PROJECT NO. IM-089-2(26) STATE BRIDGE NO. 505
MATERIAL ~~AASHTO~~ M270-GR36 ELECTRODES: E6012 HOLES: AS NOTED SHOP BOLTS:
SURFACE PREP. & PAINT:

DESCRIPTION: EXP. JOINT-ABUT.
JOB: BRIDGE 505
I89 OVER U.S. ROUTE 2
MIDDLESEX-BOLTON VT
CUSTOMER: WINTERSET INC.

DRAWN BY	DATE
	JPF	1-01
	CHKD BY	
	APPROV BY	
	Q.A.	
	JOB NO.	DRG. NO.
	127-505	J1A
		REV.

☐ NO EXCEPTIONS TAKEN ☐ REJECTED
☒ FURNISH AS CORRECTED
☐ REVISE AND RESUBMIT

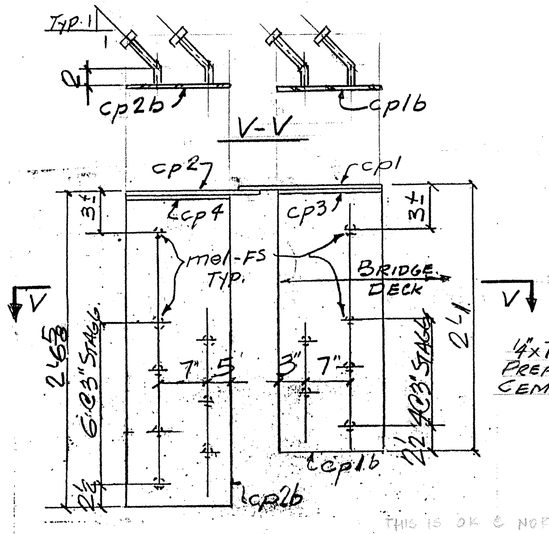
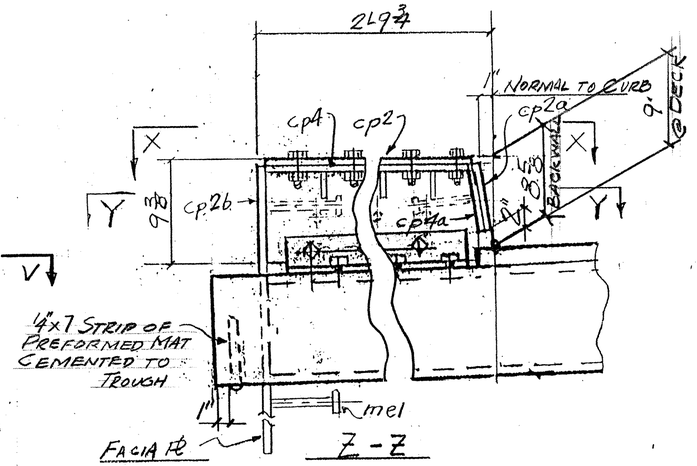
THIS IS OK @ NORTH FACE, HOWEVER 2" WILL NOT PROVIDE ADEQUATE COVER @ SOUTH FACE.
